Re: Response to Request for Site Conceptual Model and Soil & Water Investigation Work Plan  
Atlantic Richfield Company (a BP affiliated company) Station No.2111  
1156 Davis Street  
San Leandro, California  
ACEH Case No.RO0000494

Re: Response To Request For Site Conceptual Model and Soil & Ground-Water  
Investigation Work Plan, Atlantic Richfield Company Station No.2111,  
1156 Davis Street, San Leandro, Alameda County, California;  
ACEH Case No.RO0000494

Subject: Fuel Leak Case No. RO0000494 and GeoTracker Global ID T0600101764, ARCO  
#2111, 1156 Davis Street, San Leandro, CA 94577

**Figure 1**  
**Cumulative GWE Mass Removal for GRO, Benzene, and MTBE**  
Station #2111, 1156 Davis Street, San Leandro, California

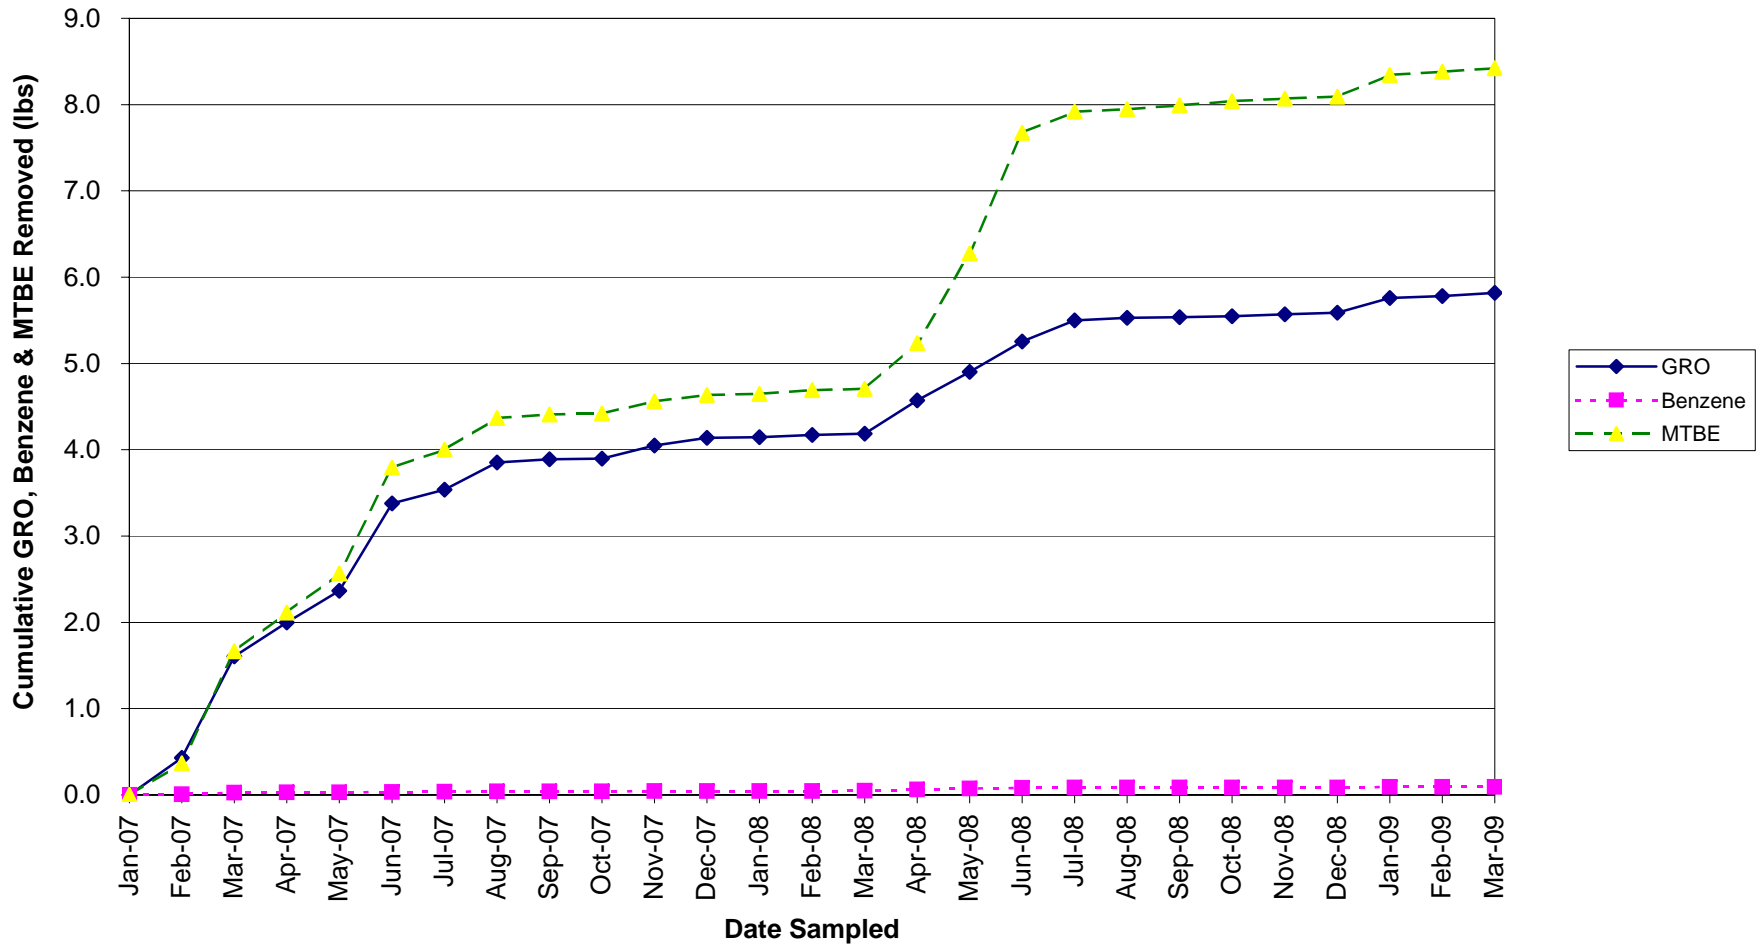
1. **Remediation Effectiveness** – In the above-mentioned remediation report, BAI includes system performance data including the quantity of contaminants removed from soil and groundwater. However, BAI does not discuss whether the system is effectively reducing hydrocarbon contamination from soil and groundwater nor does BAI include any recommendations and conclusions. Without recommendations and conclusions or an adequate evaluation of the system, ACEH is concerned that although the system may be operating, the system may not be effectively removing contaminants in a cost-effective manner. Typically, the treatment system should be evaluated followed by modifications and or adjustments so that the system continues to optimally operate and remove contaminants in a cost-effective manner. In future remediation summary reports, please include an evaluation of the treatment system as well as recommendations and conclusions.

The cumulative mass removal of GRO, Benzene, and MTBE in ground water at the Site has reached asymptotic conditions (Figure 1) and influent concentrations of GRO and Benzene in the extracted ground-water stream have decreased to levels below laboratory reporting limits (Figure 2). The cumulative mass removal of GRO as soil vapor has reached near asymptotic conditions (Figure 3) and influent concentrations of GRO in the extracted vapor stream have been inconsistent but recently decreased below laboratory reporting limits (Figure 4). Based on the decreasing concentration trends observed in the wells associated with the Site (Figures 5-8), the asymptotic mass removal conditions associated with the remediation system, and the observed system influent concentrations below laboratory reporting limits, it is recommended that operation of the DPE system be discontinued. The remediation system is no longer cost effective and concentrations observed on-site do not warrant operation of the system.

**Figure 5**  
**MW-2 Concentrations vs. Time**  
**ARCO Station #2111**  
**1156 Davis Street, San Leandro, California**

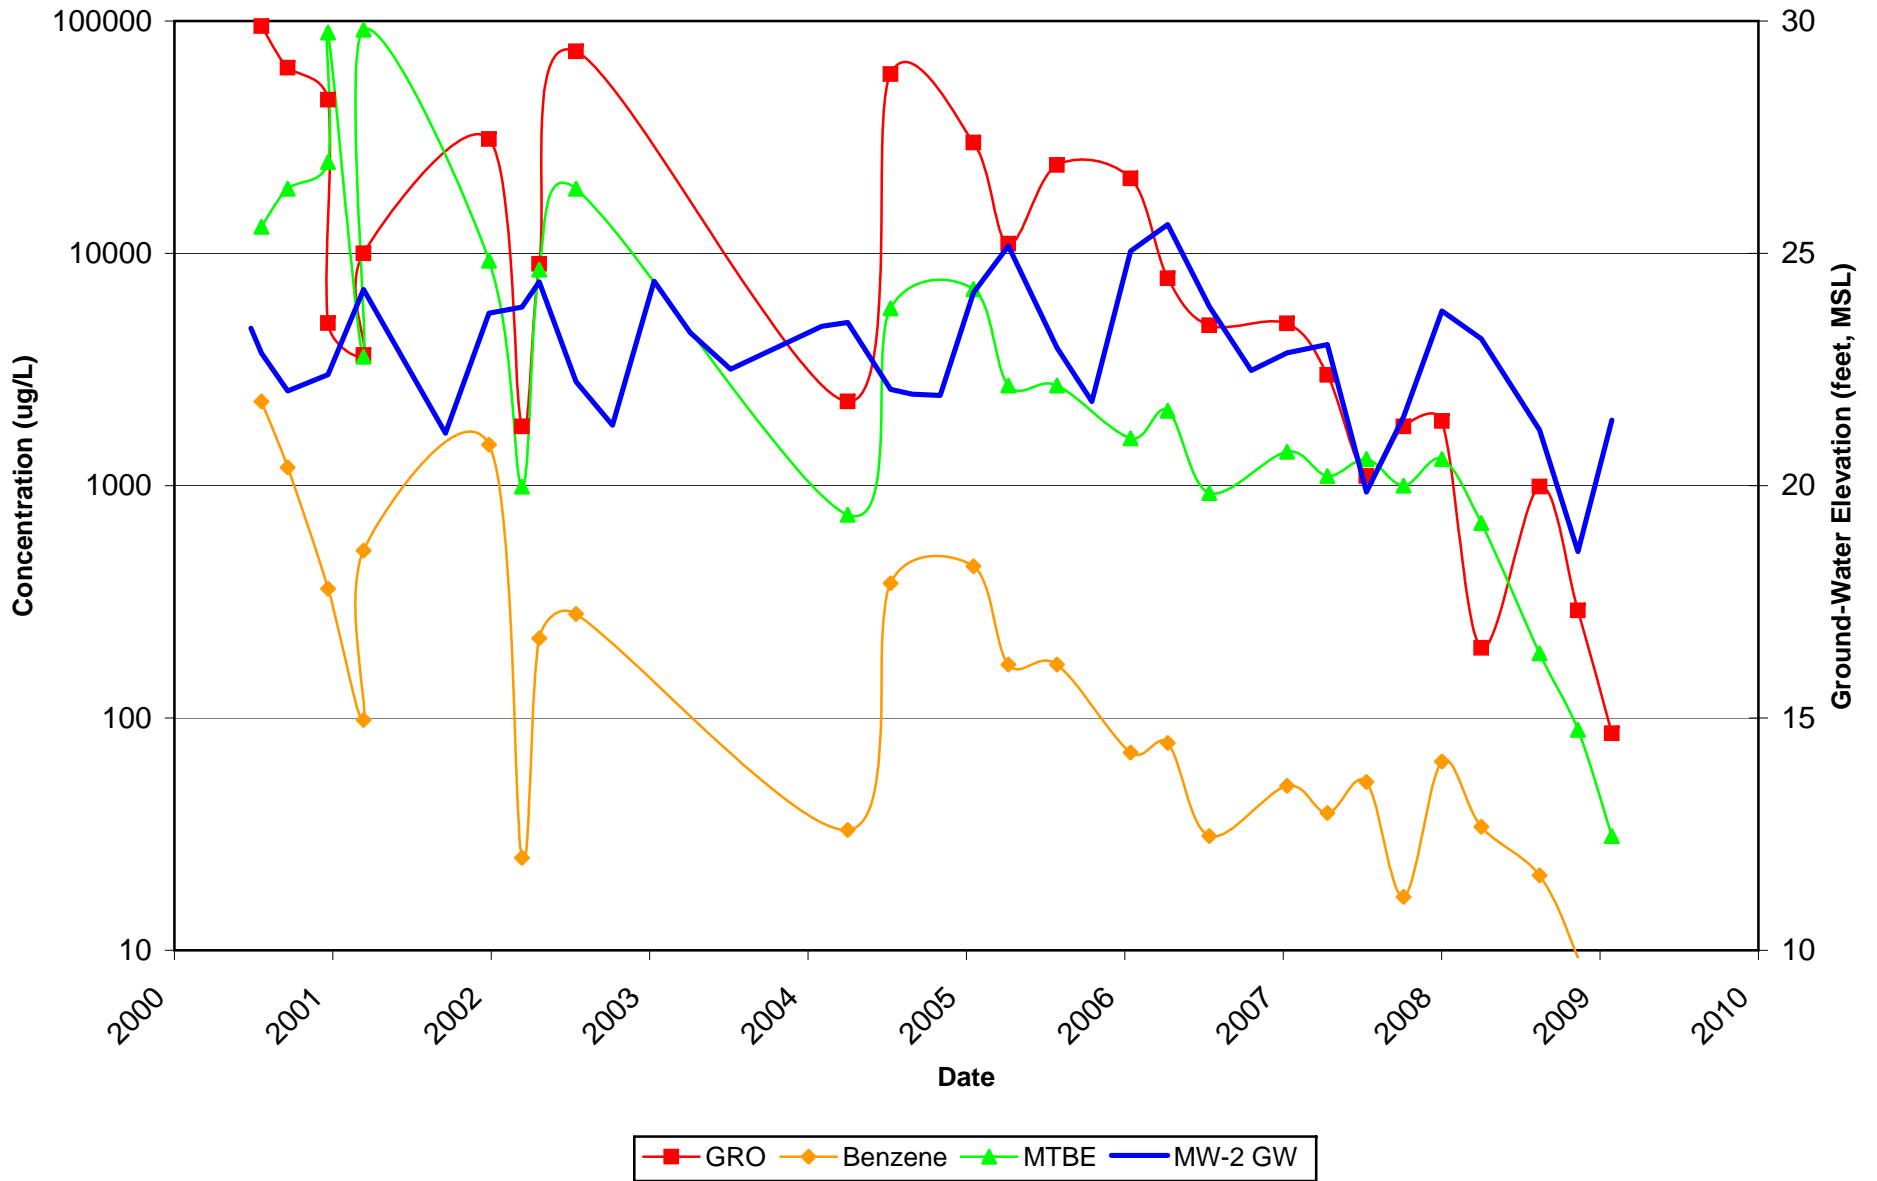
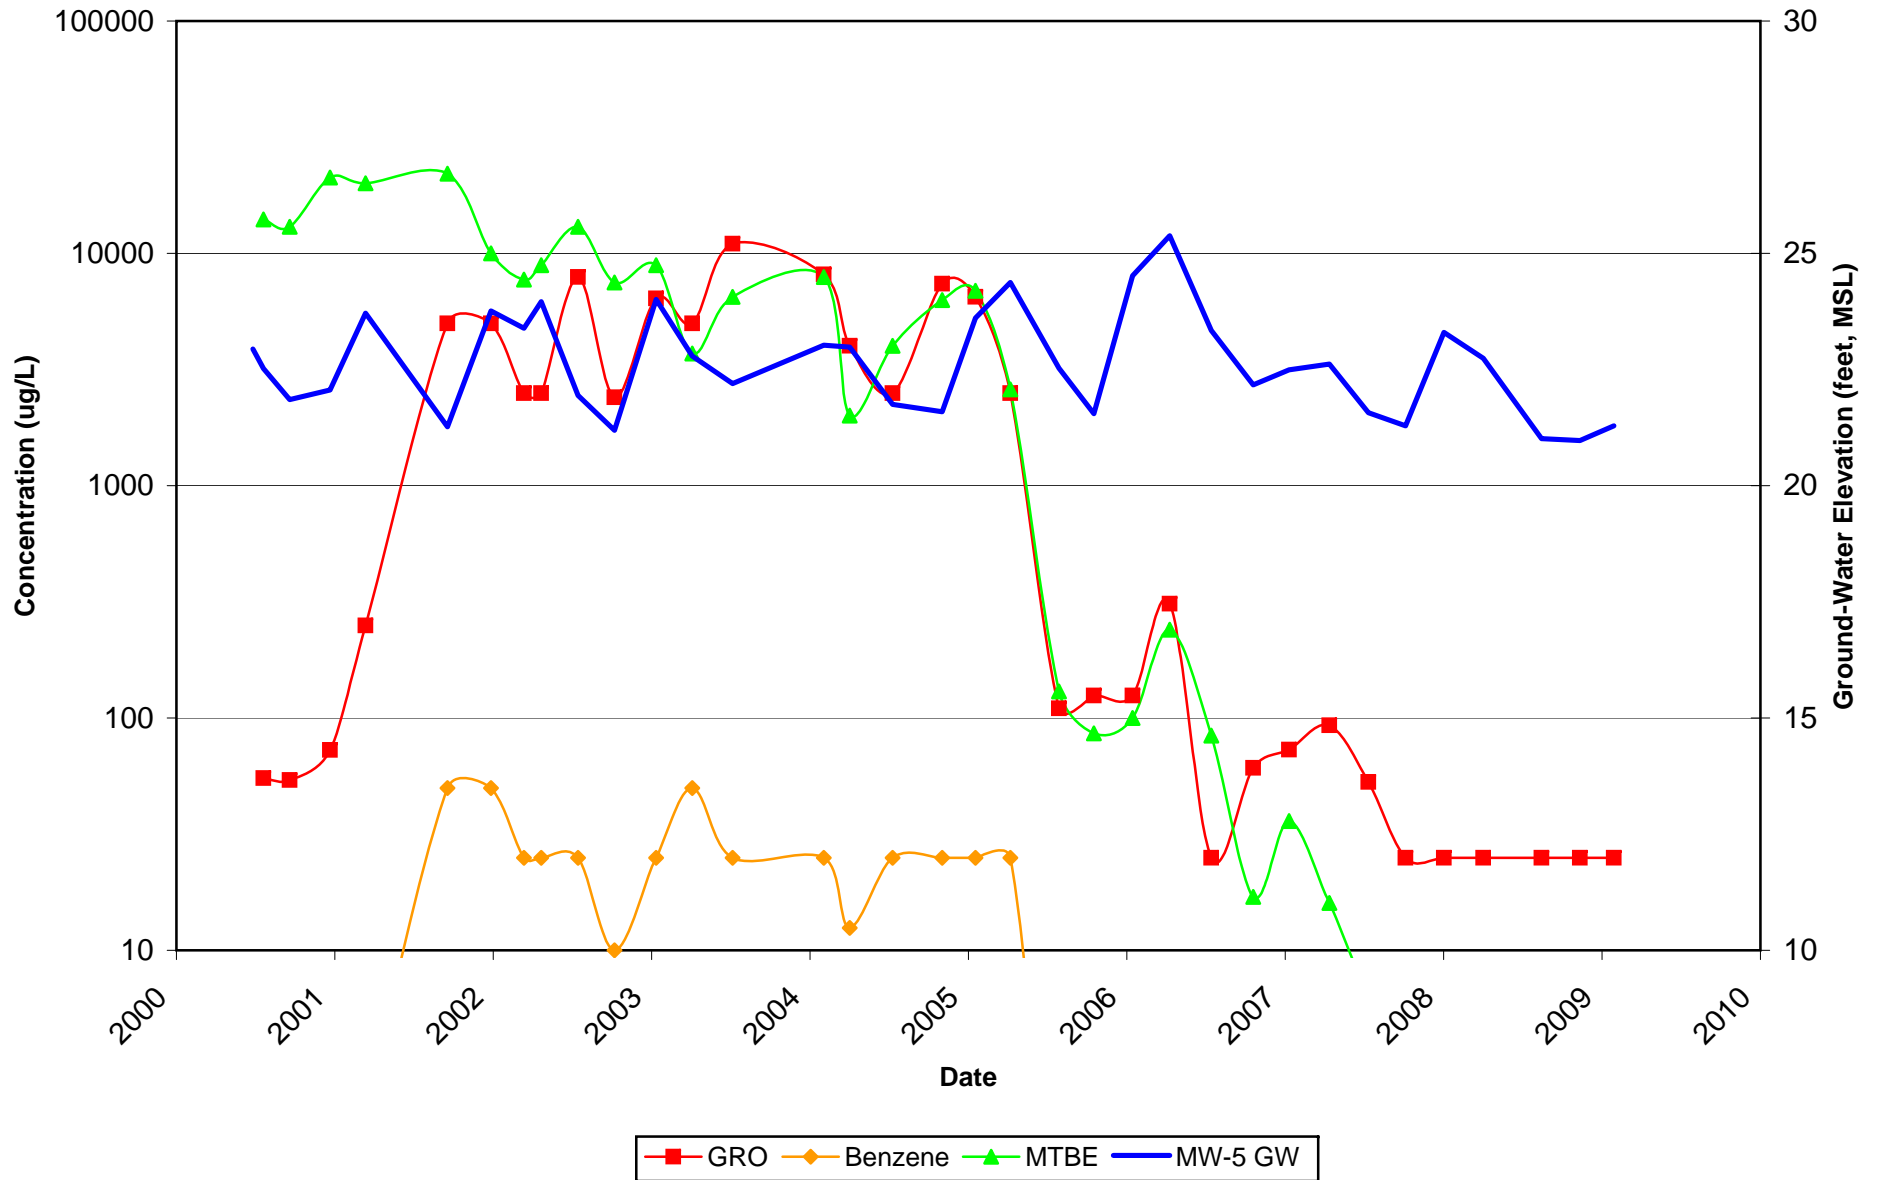
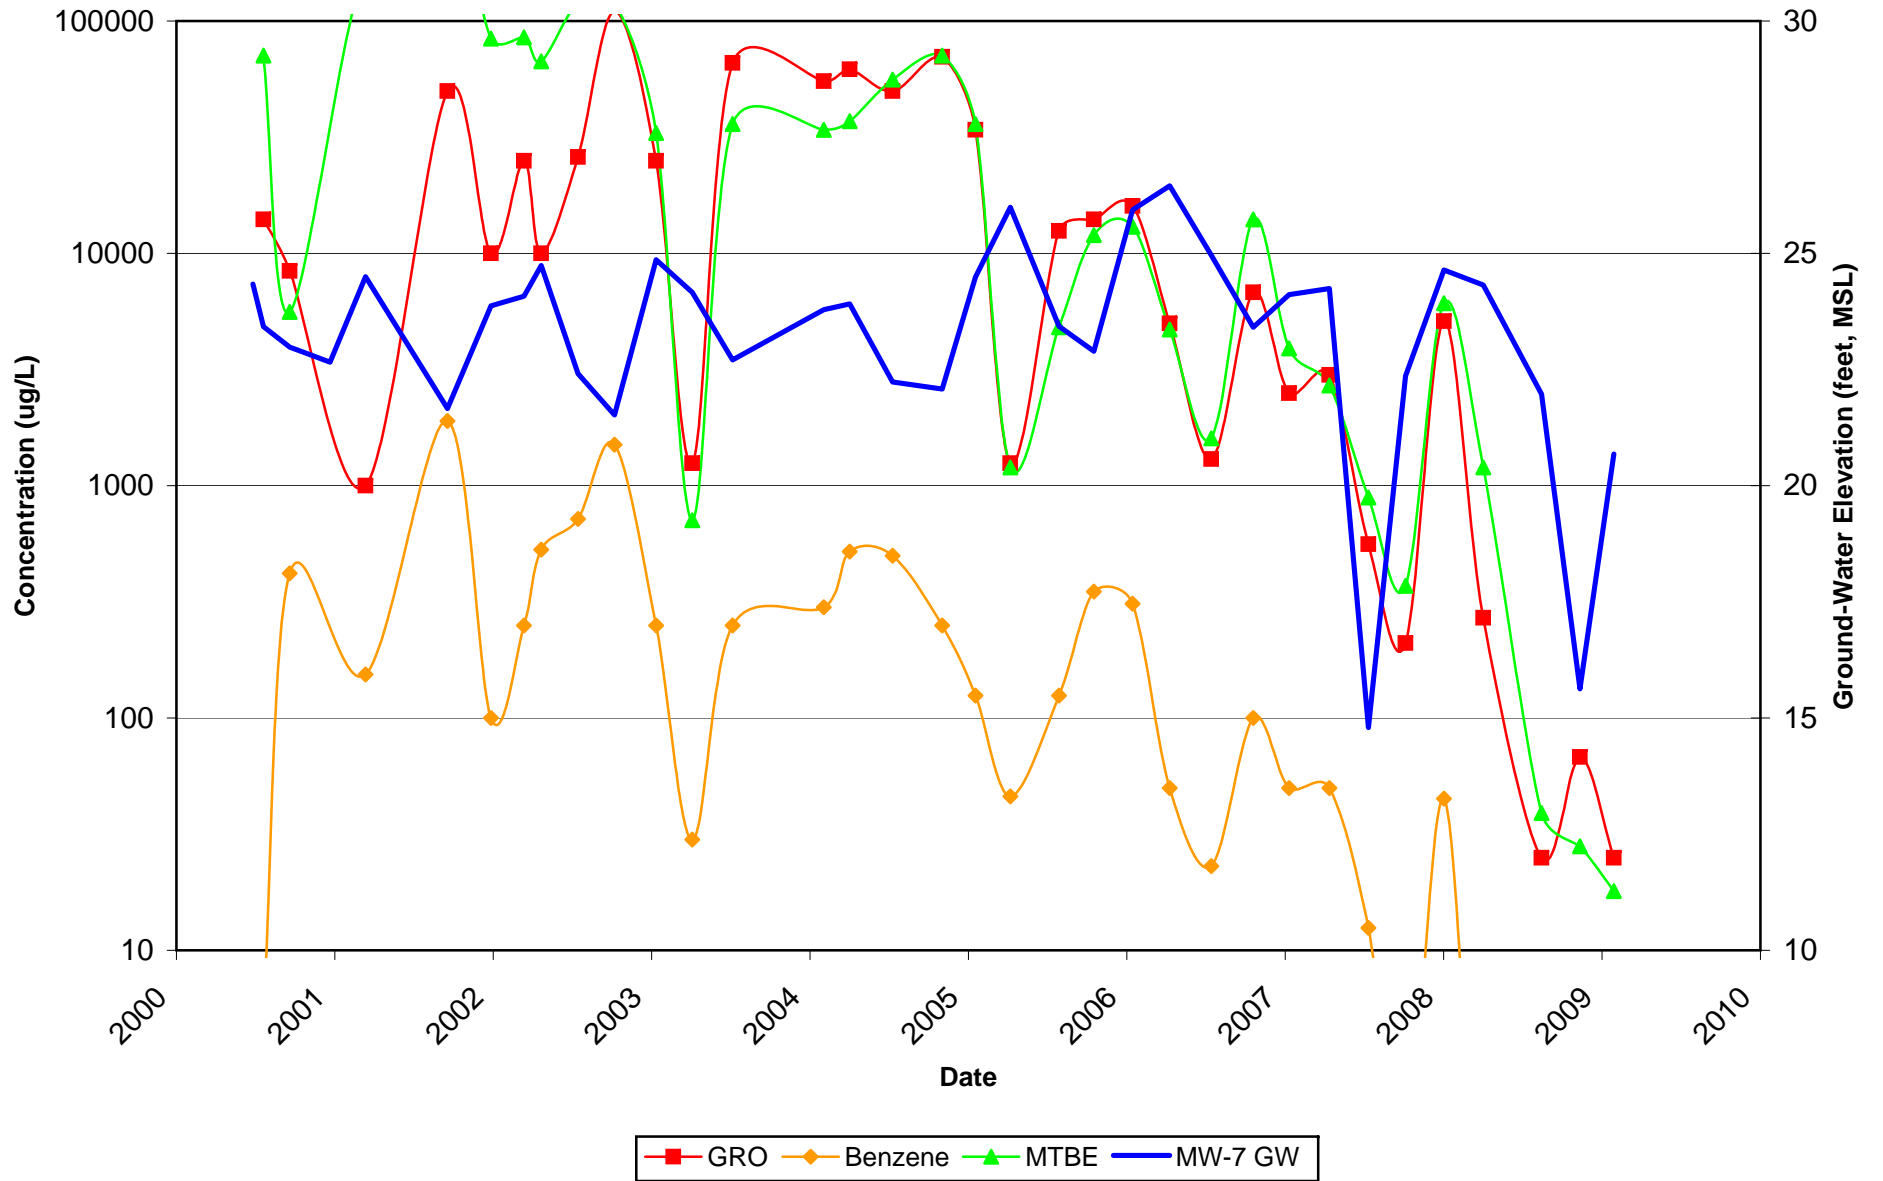
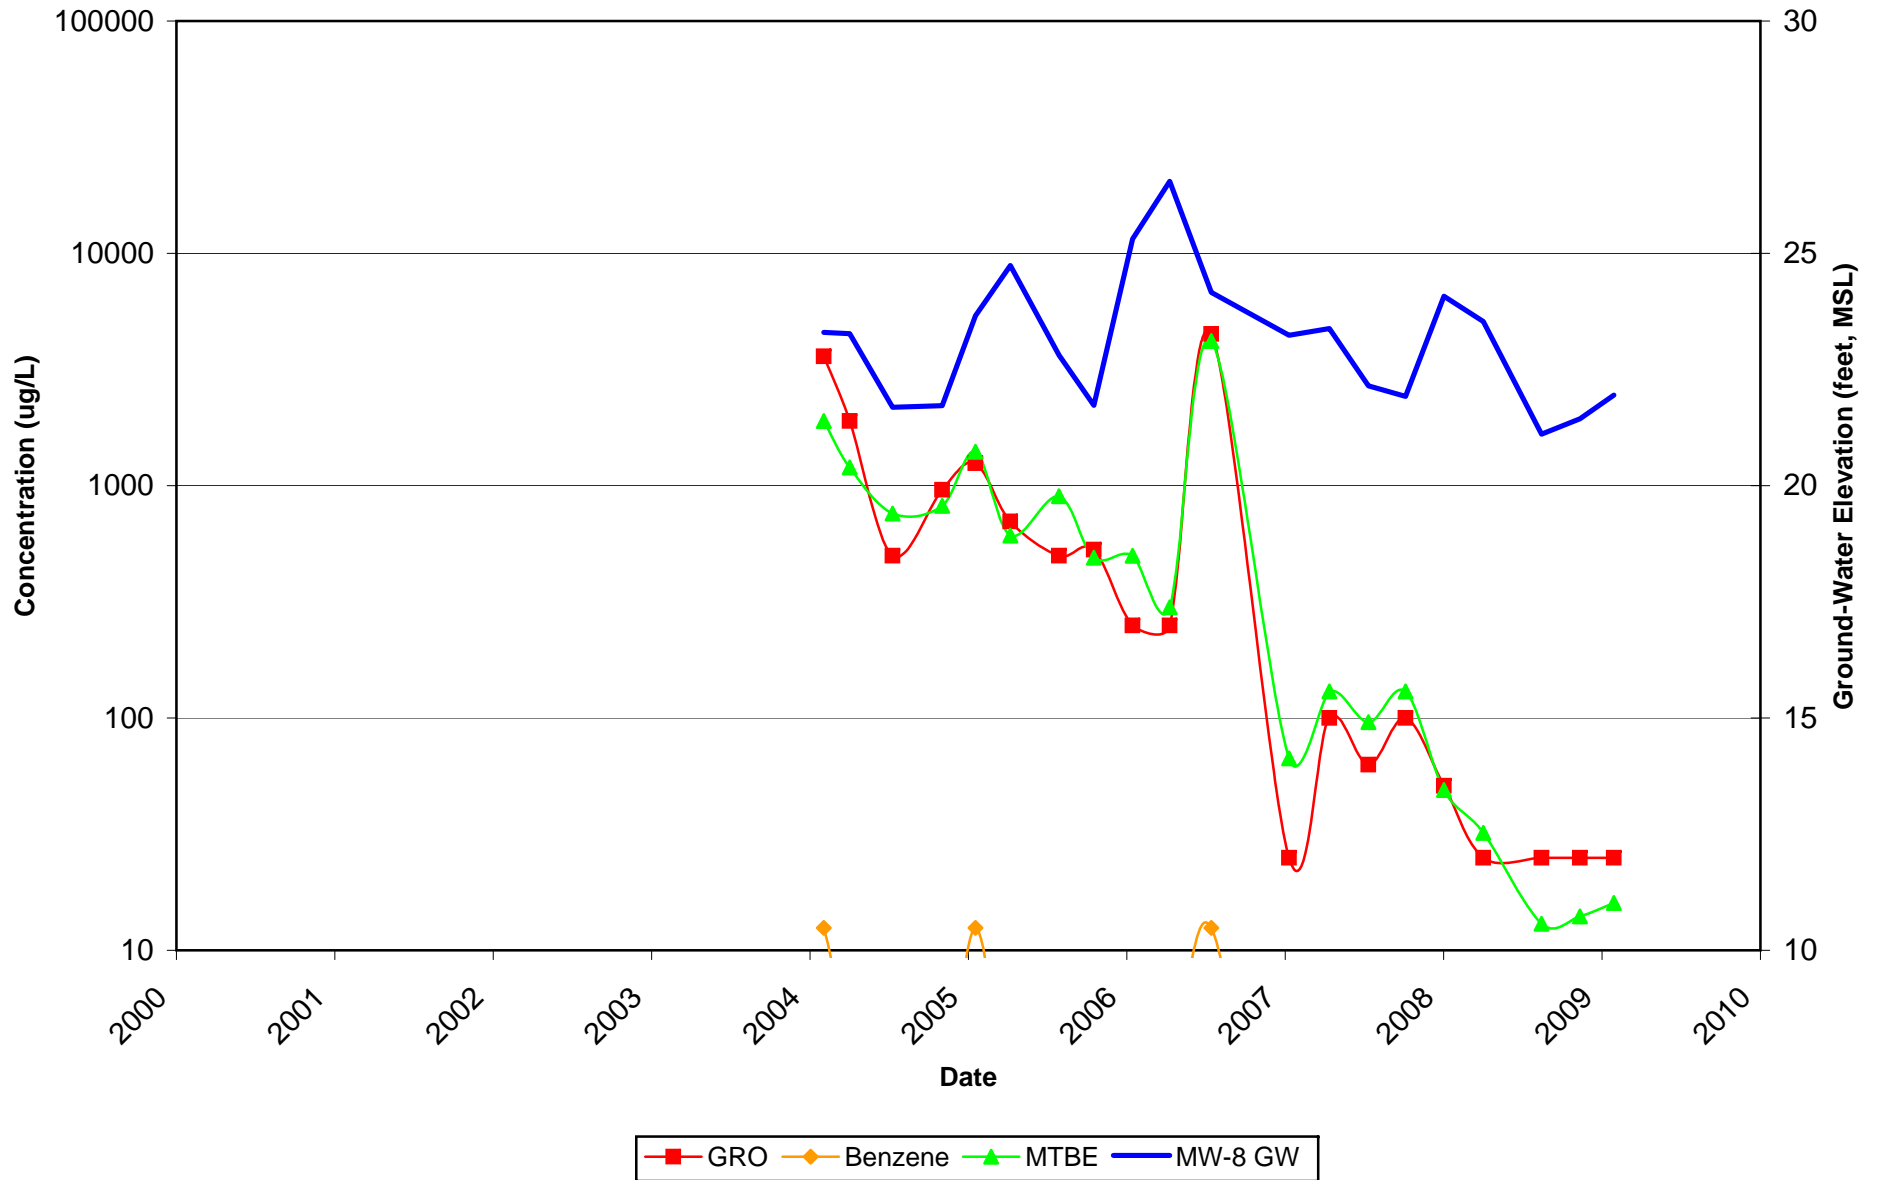
4. **Site Conceptual Model** – At this juncture, it may be advantageous to develop a site conceptual model (SCM), which synthesizes all the analytical data and evaluates all potential exposure pathways and potential receptors that may exist at the site, including identifying or developing site cleanup objectives and goals. At a minimum, the SCM should include:

Contaminant concentrations observed on-site have dramatically decreased since startup of the DPE system in 2007 (See Figures 5-8). This downward trend suggests that the remediation system has effectively decreased contaminant concentrations at the Site. The main constituents present within the ground-water at the Site include GRO, Benzene and MTBE. Recent laboratory analytical results from samples collected in wells associated with the Site indicate that the majority of the contaminant concentrations are below the Environmental Screening Levels (ESLs) established by the San Francisco Bay Regional Water Quality Control Board (SFRWQCB). A summary table with the concentration range of GRO, Benzene, and MTBE observed at the Site over the last year and the ESLs for each constituent is provided below.
